DC METROPLEX BWI COMMUNITY ROUNDTABLE

September 8, 2017

Michael P. Huerta
Administrator
U.S. Department of Transportation
Federal Aviation Administration
800 Independence Avenue, SW
Washington, DC 20591

Figure 1A Runway 28 Departures - shows specific examples of aircraft flying where they were not flying prior to DC Metroplex/NextGen.

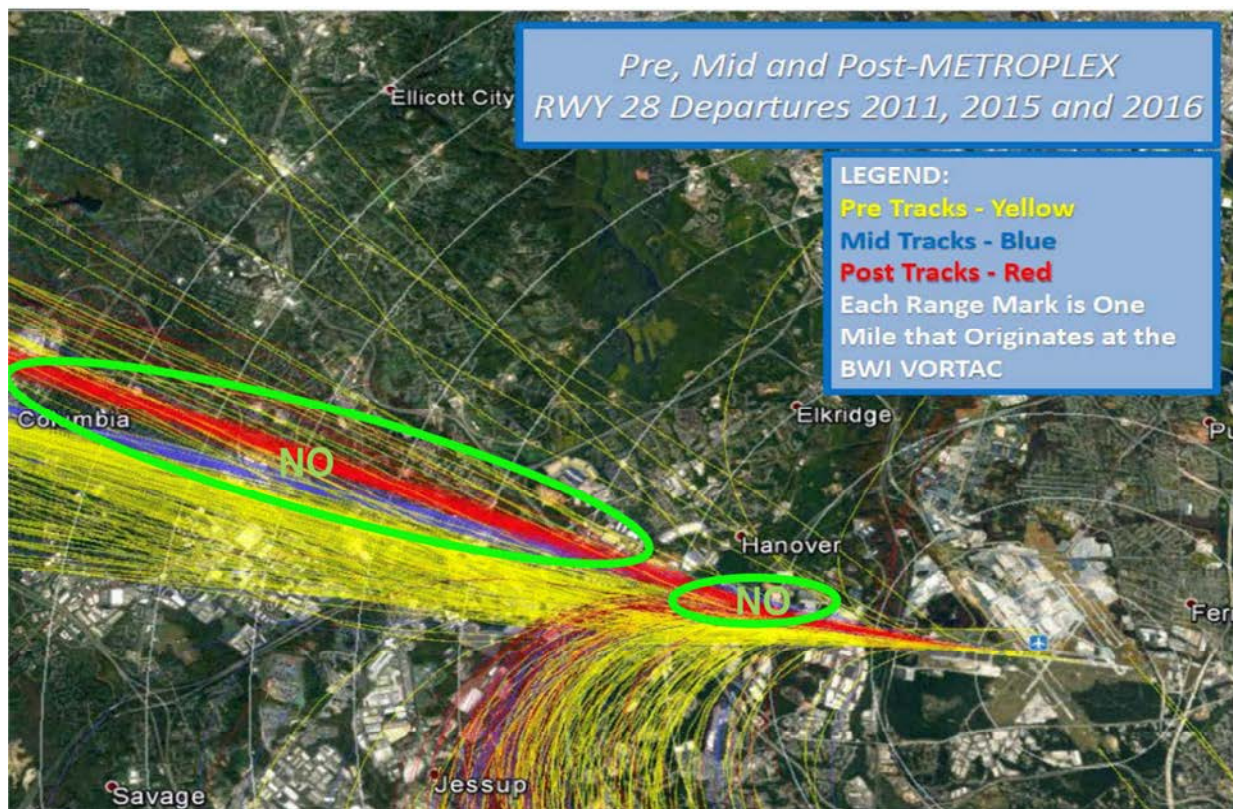
1. New flight paths have been created by DC Metroplex/NextGen; FAA must revert to old flight paths. Thousands of community residents have observed aircraft flying along flight paths that were not being flown previously. See Figures 1A, 2A and 3A and FAA flight path diagrams in Attachments 1 and 6 for comparison and as representative examples. These new flight paths include, among others:

- Runway 28 departure – early turn and path shift to the north and flying south at low altitude
- Runway 15 departure – earlier and lower turn
- Runway 33L and 10 arrivals – flights cleared direct to any waypoints from the RAVNN arrival (including waypoints GRAFE, SPLAT, JANNS)

We have been advised by Ms. Ray and other FAA representatives that the FAA will be working to revert on the turns and flight paths for runway 28 and 15 departures.

Figure 3A Runway 33L Arrivals - as well as figures 1 and 2 above, show examples of how planes are now concentrated into narrow corridors so that plane after plane are destructive for the residents beneath.

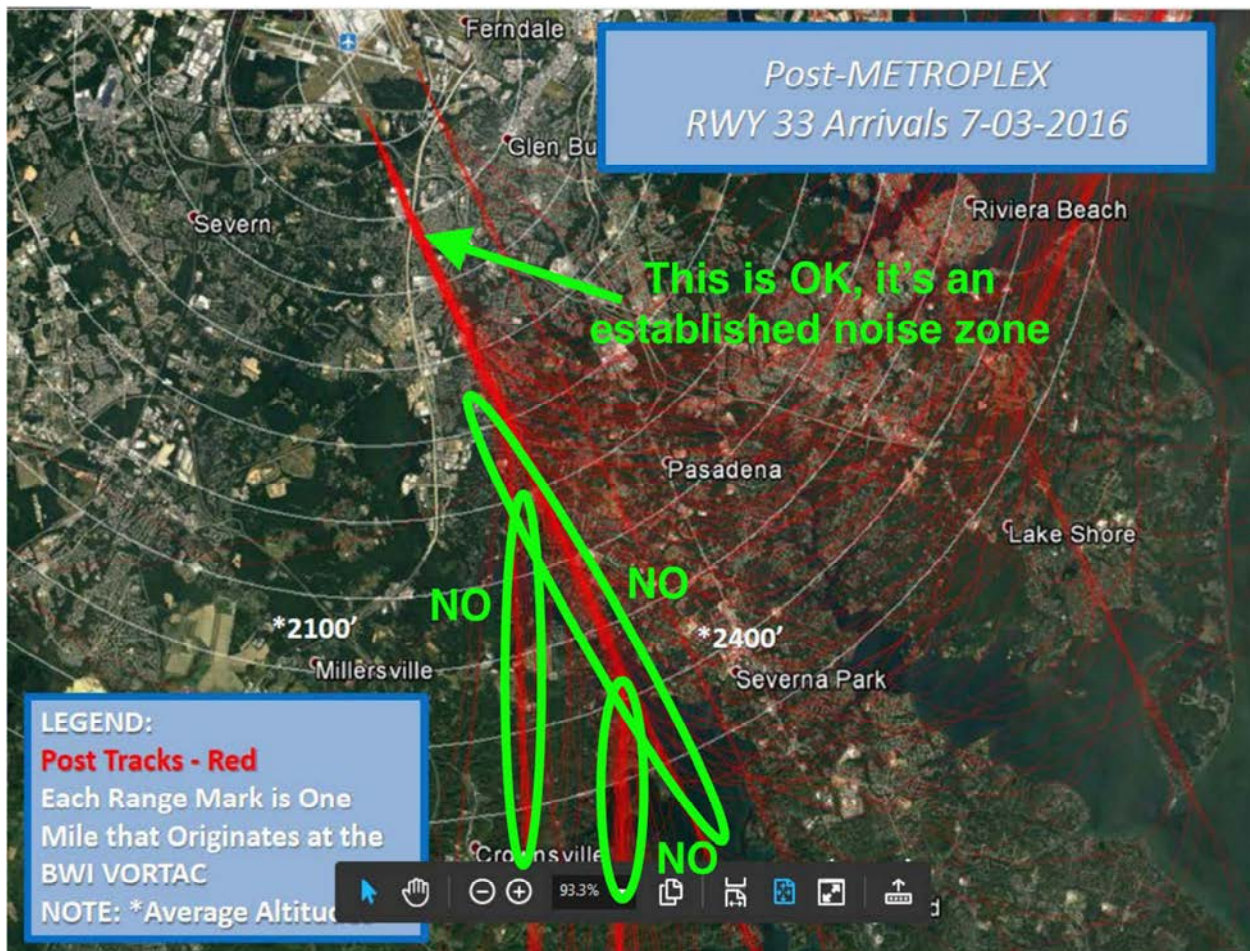
Regarding runway 33L, as discussed at the Roundtable's July 18, 2017 meeting and requested in the Roundtable's letter to the FAA, dated July 25, 2017 (see Attachment 7), aircraft would not be "cleared direct" to GRAFE, SPLAT or JANNS but would be vectored to the final approach course with the objective of achieving dispersion consistent with that illustrated in Attachment 1. Runway 10 arrivals, the ANTHM3 and TRISH2, also have resulted in concentrated flights upstream and at lower altitudes which are unacceptable.

2. DC Metroplex/NextGen has resulted in a concentration of flight paths in narrow corridors; FAA must revert to old procedures that were effective in achieving dispersion. The concentration of low flying aircraft along the departure and arrival flight paths has been disastrous for residents underneath them. Numerous studies have demonstrated the harmful effect on mental and physical health due to aircraft and low frequency noise. In addition to the health effects, there is a questionably constitutional taking by the FAA of the residents' quiet and peaceful enjoyment of their homes and attendant economic loss due to lower property values. A comparison of pre- and post-DC Metroplex/NextGen flight paths as shown on Attachments 1 and 6 clearly shows the concentration of flight paths post-DC Metroplex/NextGen and that those under the flight paths would be significantly impacted is intuitive.

Figure 3B Runway 33L Arrivals - shows dispersion and features of pre-DC Metroplex/NextGen arrivals that must be restored.

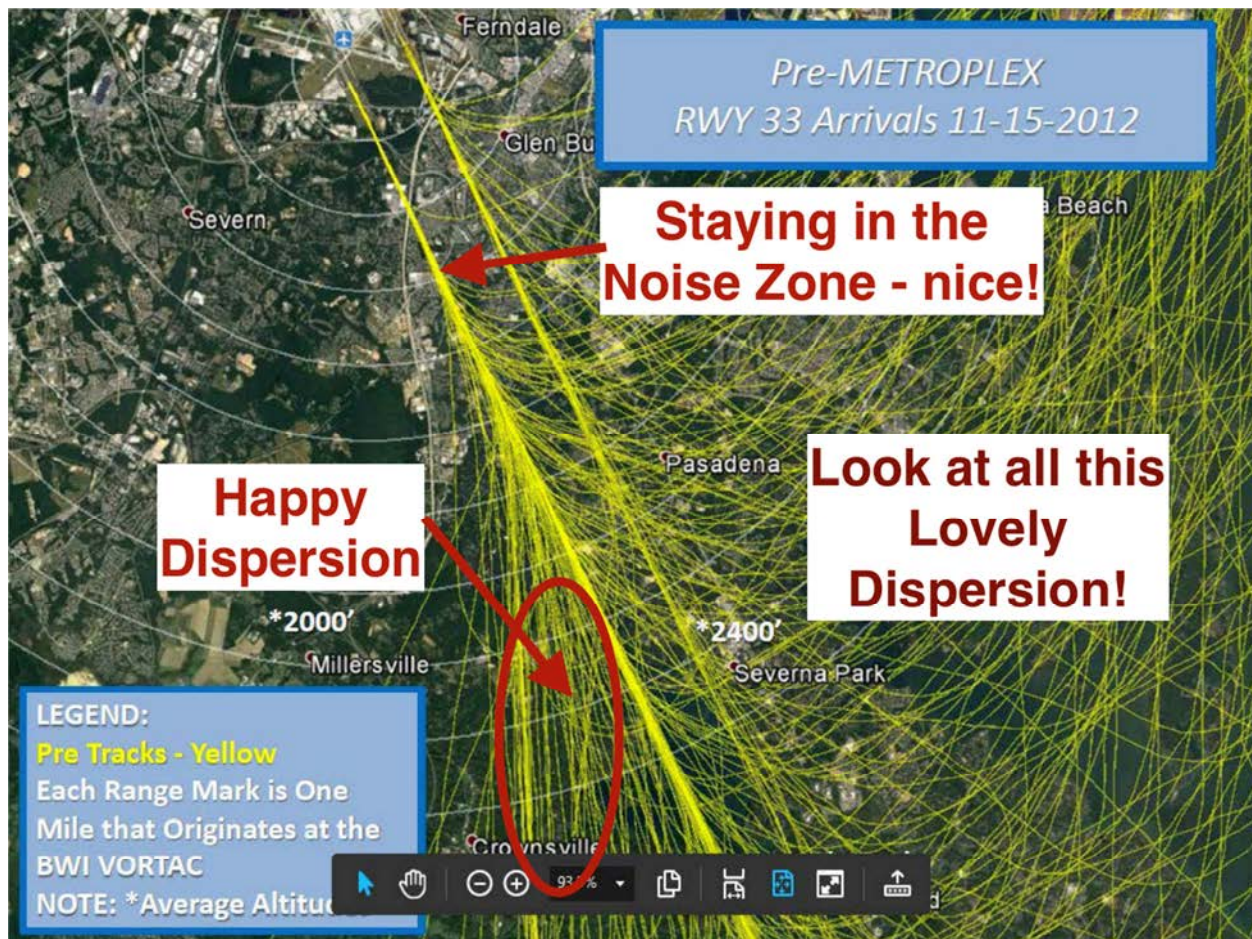
The June 20 presentation did not provide for notional zones to deal for dispersion on arrivals, but notwithstanding the presentation, Ms. Ray communicated at the meeting and in subsequent communications that the FAA understands the problem of concentration and the request for dispersion (examples of which are shown on Attachment 1) and would undertake efforts to recreate that dispersion on arrivals.

Figure 4 Vertical Profiles – shows how planes are flying at lower altitudes than necessary, as has been observed on all arrivals, particularly bothersome with arrivals on Runway 33L and Runway 10.

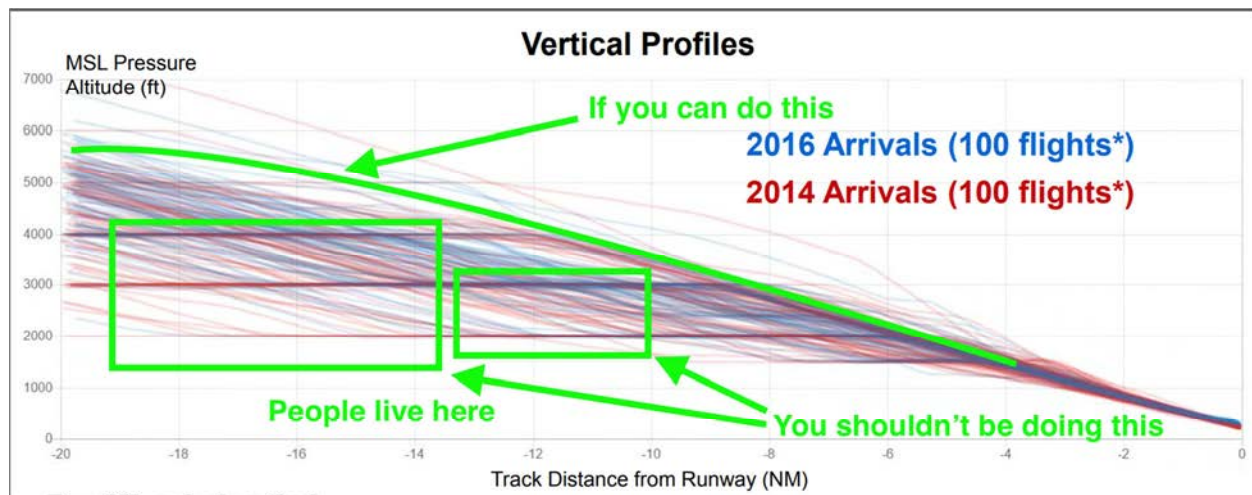
3. FAA procedures permit aircraft to fly at altitudes too low; procedures must be modified to require aircraft to fly at the highest safe altitude at all times during departures and arrivals. Residents universally state that aircraft are flying lower under the DC Metroplex/NextGen scheme than previously. We understand there is conflicting data about how low aircraft are flying and issues regarding whether representations regarding aircraft altitude in DC Metroplex environmental assessment were accurate. As stated by FAA operations representatives for BWI approach control, the frequent ATC procedure of clearing aircraft for visual approaches has had the effect of alleviating an aircraft's obligation to comply with published arrival and approach procedure altitudes resulting in much lower flying aircraft. This has directly translated into an unacceptably lower altitude for regular flight operations. For arrival aircraft this has affected flights from as far out as the RAVNN waypoint on the RAVNN arrival and their joining of the final approach corridor into 33L at lower than IFR standard glideslope intercept altitudes. For 15R departures this has resulted in aircraft turning at lower altitudes; altitudes should be restored to previously established altitudes and the turn should be restored to 1 DME.

Also in our July 25 letter to the FAA, we have requested that the FAA implement the cooperation and training as proposed by Robert Owens at the July 18 meeting as soon as possible. We further request that FAA and airport procedures and rules be changed so that achieving and maintaining the highest safe altitude for departing and arriving aircraft is a requirement, rather than only a voluntary undertaking. All flights given visual clearances must not descend below published altitudes for the entire arrival and approach procedure.
